Model: Baron-P3/C3	Date: 22-Mar-19	No.: RD0BX001a
--------------------	-----------------	----------------

Subject: Production delay of the Feed Rollers		Prepared by: S. Katoh	
From: Sales Strategy Section, 1st CP Business Dep.			
Classification:	<input type="checkbox"/> Troubleshooting	<input checked="" type="checkbox"/> Part information	<input type="checkbox"/> Action required
	<input type="checkbox"/> Mechanical	<input type="checkbox"/> Electrical	<input type="checkbox"/> Service manual revision
	<input type="checkbox"/> Paper path	<input type="checkbox"/> Transmit/receive	<input type="checkbox"/> Retrofit information
	<input type="checkbox"/> Product Safety	<input type="checkbox"/> Other ( )	<input checked="" type="checkbox"/> Tier 2

**Notice Regarding the New Paper Feed Roller**

**Notice Regarding the New Drum Charge Unit**

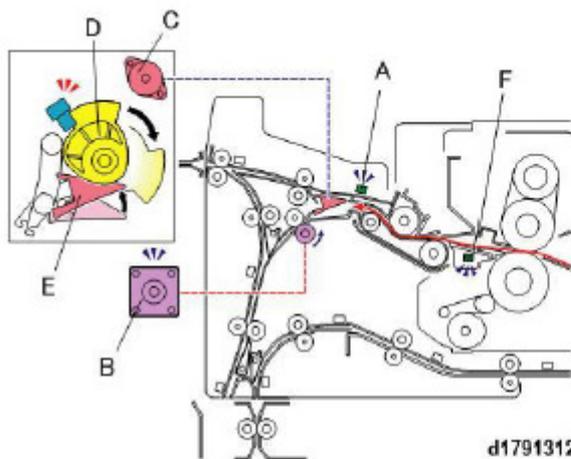
The drum charge unit for the Pro 8300 Series was changed of the material from the predecessor.

The drum charge unit was supposed to be ready prior to launch, but due to delay in production, the new drum charge unit is not installed on the mainframe and not procurable as spare parts as of the time this bulletin was released.

Instead, the old units will be installed on the mainframe and supplied as service parts until the new units become available.

Part Description	Old p/n	New p/n
CHARGE CORONA	D1792255	D0BX2255
GRID: CHARGE CORONA	G1782500	D0BX2500

Fig.2

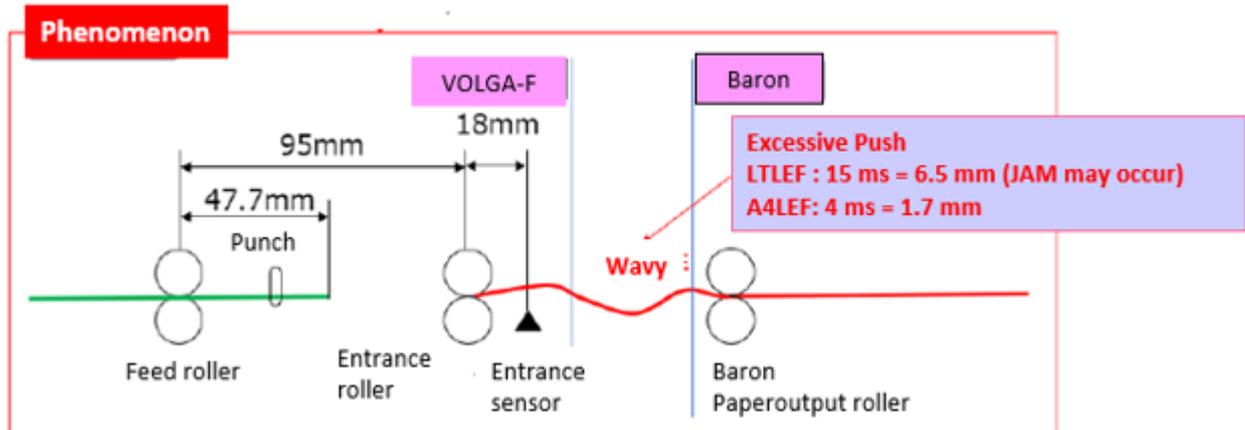
The punch mode of VOLGA-F was not compatible with 96 ppm and 90.5 ppm was the limit, and the punch mode was supposed to correspond with 90.5 ppm in the concept design. But, there is a mounting error of "A notification of paper interval notified to the main unit from VOLGA-F" as the firmware issue, and the punch mode at the time of proof tray discharge is 96 ppm, and the control is not in time.

- A: Control time required for completion of LTLEF punching in VOLGA = 640 m sec
- B: Time between sheets in proof tray (96 ppm) = 625 m sec

$B - A = - 15 \text{ m sec}$  ; Control of VOLGA-F is not in time

Apply the IGUAZU new firmware described below table when it is installed with Baron-C3/P3.

Firmware change to ensure the margin of 29 m sec (12.5 mm) against the condition where 15 m sec (6.5 mm) control can not be made in time. As a result, the same productivity (90.5 ppm) as shift tray punch mode.

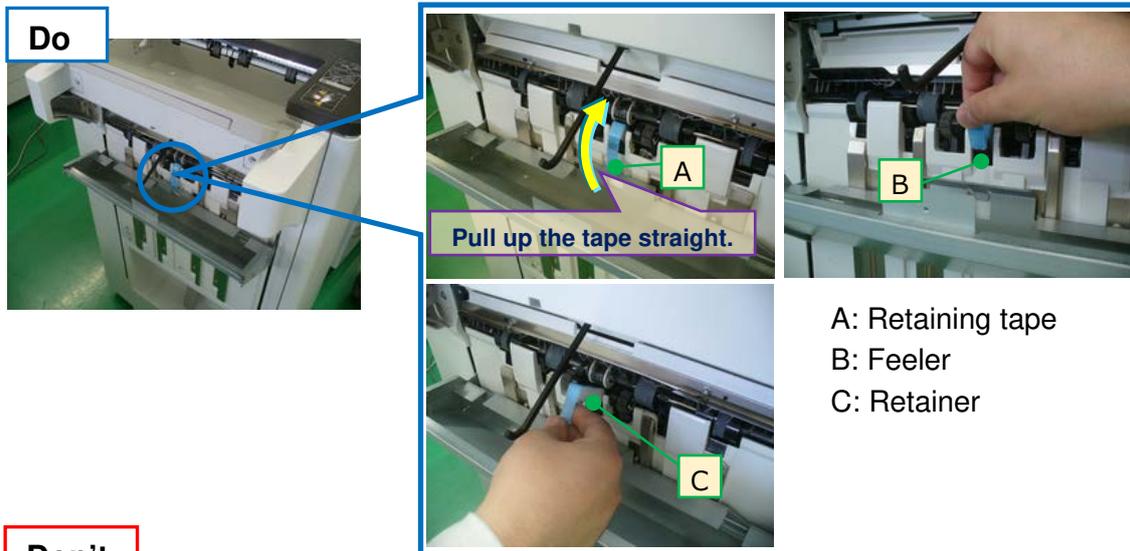
The paper feeler on the shift tray may come off when removing its retaining tape at installation.

***Turning On the machine power with the feeler detached causes the shift tray to descend to the lowest position followed by J493 (Tray Lift Motor Jam). Power cycling Off/On in this condition will display the message 'Remove the paper from Finisher Shift Tray' on the operation panel.***

Do not remove the retaining tape side by pulling it sideways. Instead, pull it up straight.

### Permanent solution

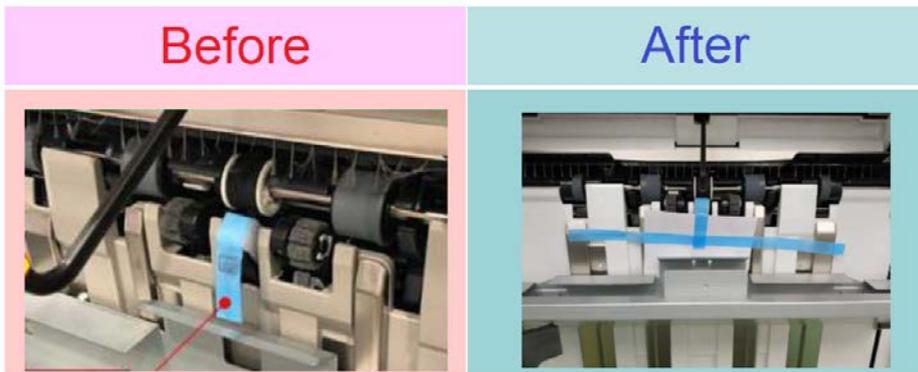
The retaining tape was modified.

- *Booklet Finisher SR5100 D3GC17: 3649Q310038 ~*
- *Finisher SR5090 D3GD17: 3659Q410001 ~*

Fig.2 DLT (JAM132)

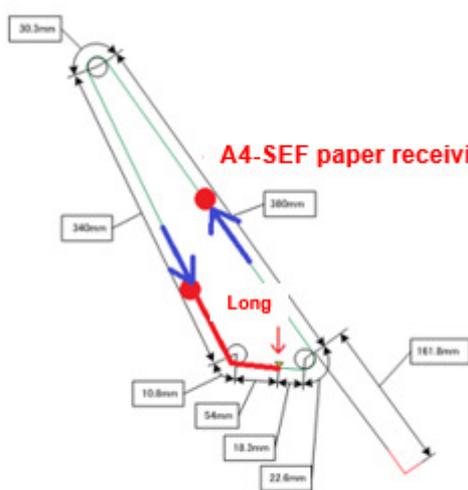
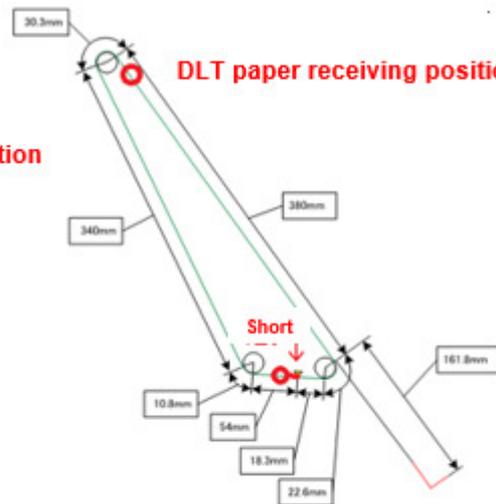
A soft bug caused by the fact that the homing sequence of the tip stopper did not consider reaching the HP sensor during motor start up.

When the leading end stopper is moved to the DLT size paper receiving position, the distance between the leading end stopper and the leading end stopper HP sensor decreases. In the subsequent homing process, the HP sensor is reached during motor start-up, and the homing process is not completed at the target timing, leading to a timeout (J132).

Apply the IGUAZU new firmware described below table when it is installed with Baron-C3/P3.

**Notice regarding change in Toner Refresh threshold**

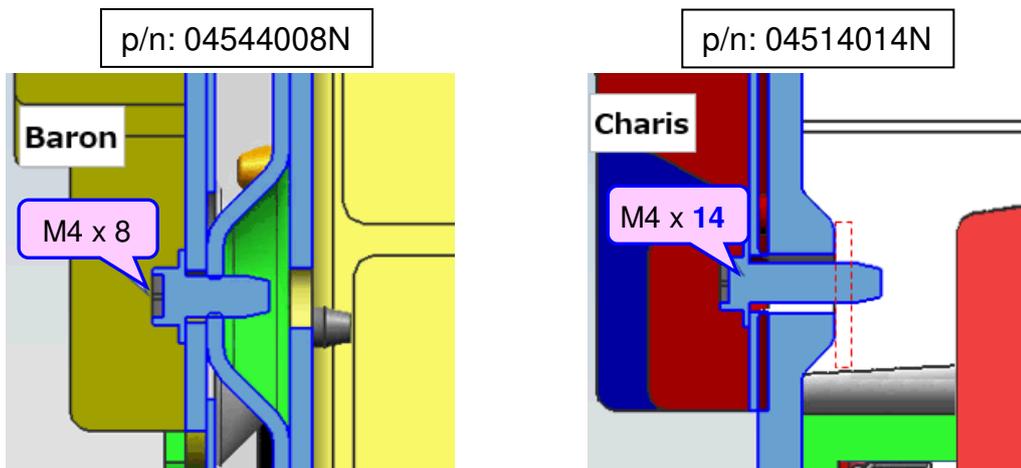
- The 'Toner Refresh' threshold will change from **3%** to **2%** in the below f/w scheduled for release in **July 2019**.
- Until then, please change the setting manually in **SP3-820-001**, as necessary.
- When the modified f/w becomes available update the following f/w as a set for the change to take effect.
  - ◇ **Engine Ver.1.21**
  - ◇ **Controller Ver.1.04**

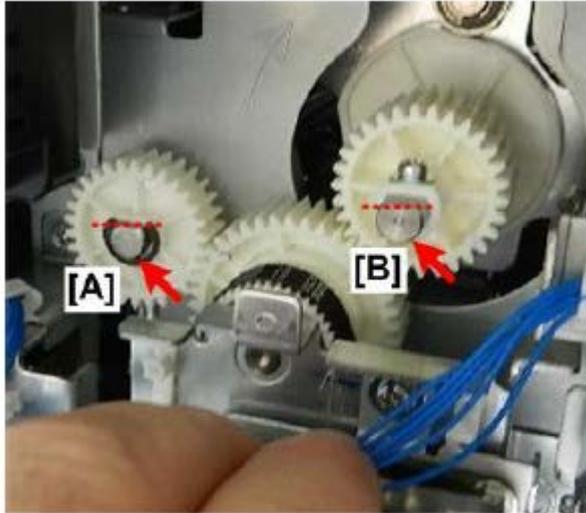
Before you re-attach the Registration Gate Roller Motor, make sure that the D-cut flat edges [A] and [B] on both shafts face up and are parallel.

Holder and Bracket position viewed from front

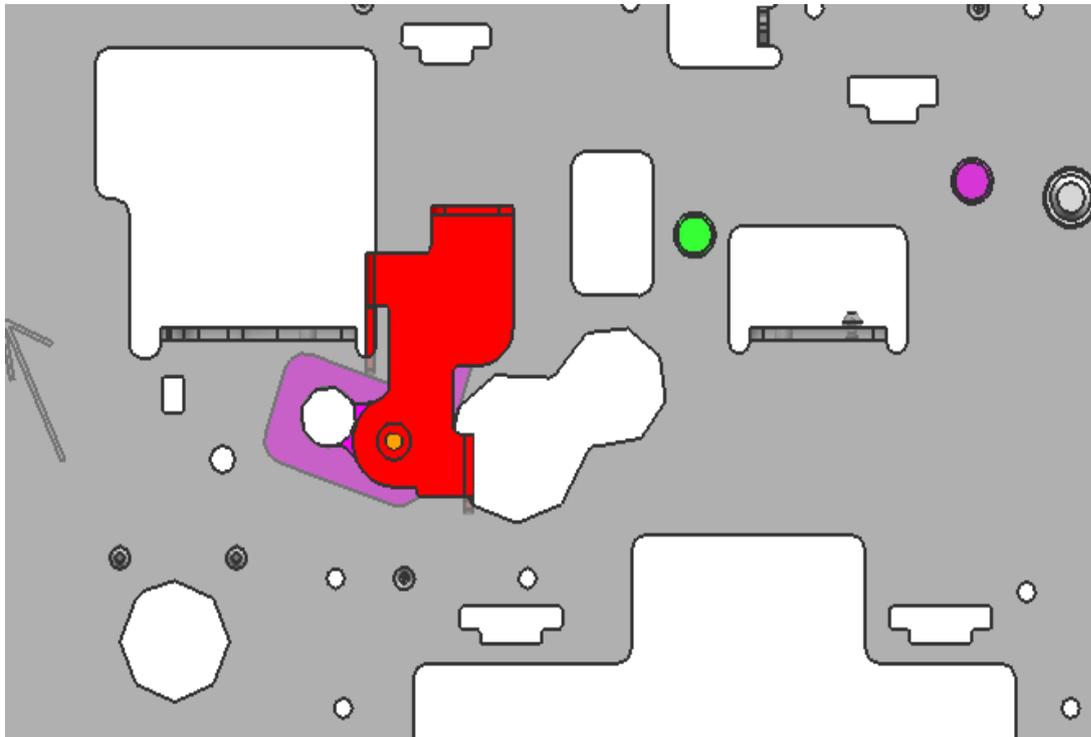
Added a holder and bracket, to firmly support the timing roller in the slot.

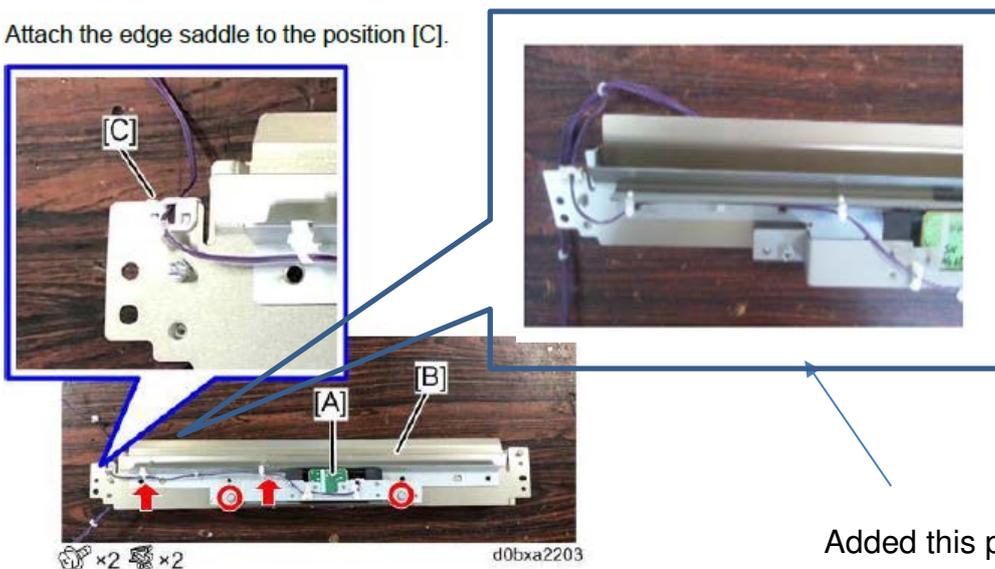
Added this picture.

5. Attach the edge saddle to the position [C].

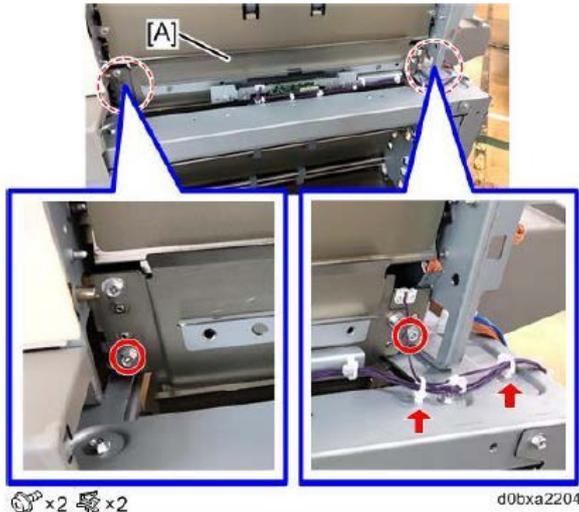
Changed the descriptions as follows.

- 6. Attach the guide plate [A]. (M4x8)

No. 35.

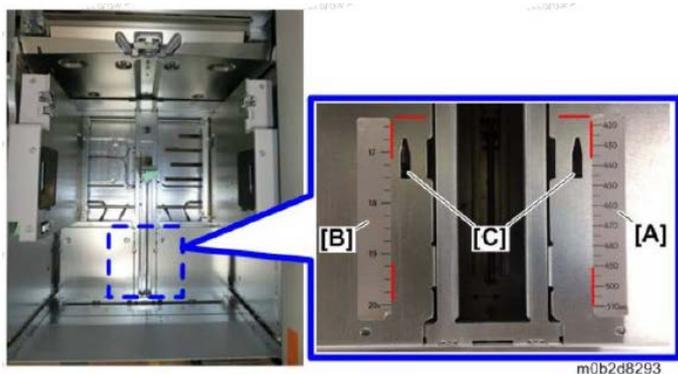
2. Installation > Vacuum Feed Banner Sheet Tray > Before  
Changed the instruction and photo.

Attach the scale decals [A] and [B] by referring to the red markings.

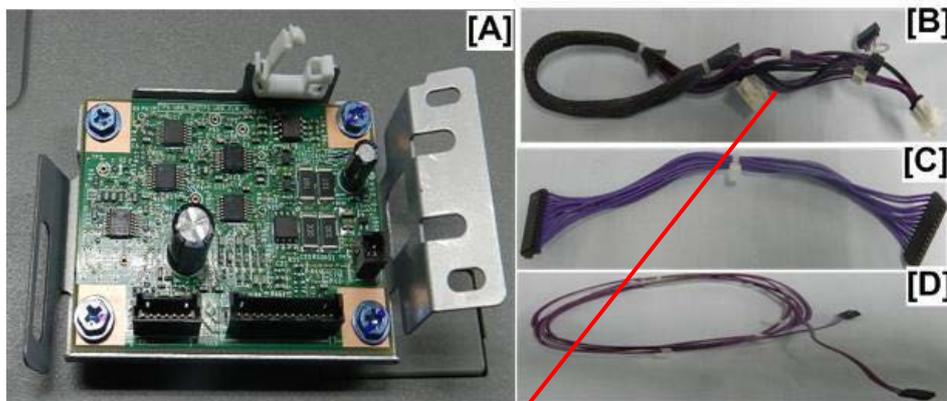
Corrected the description and photo for [B] as follows.

9. Gather these items:

Correction 4-3

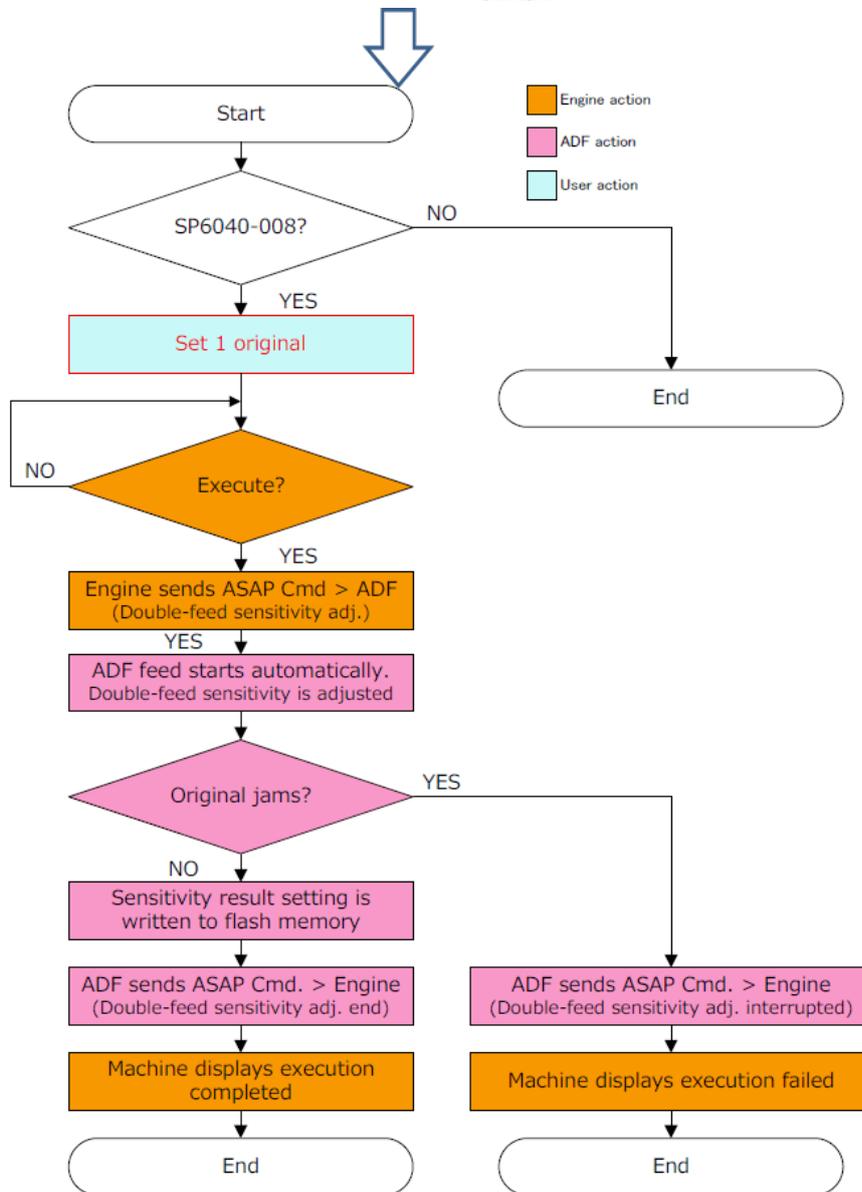
Replaced the flow chart.
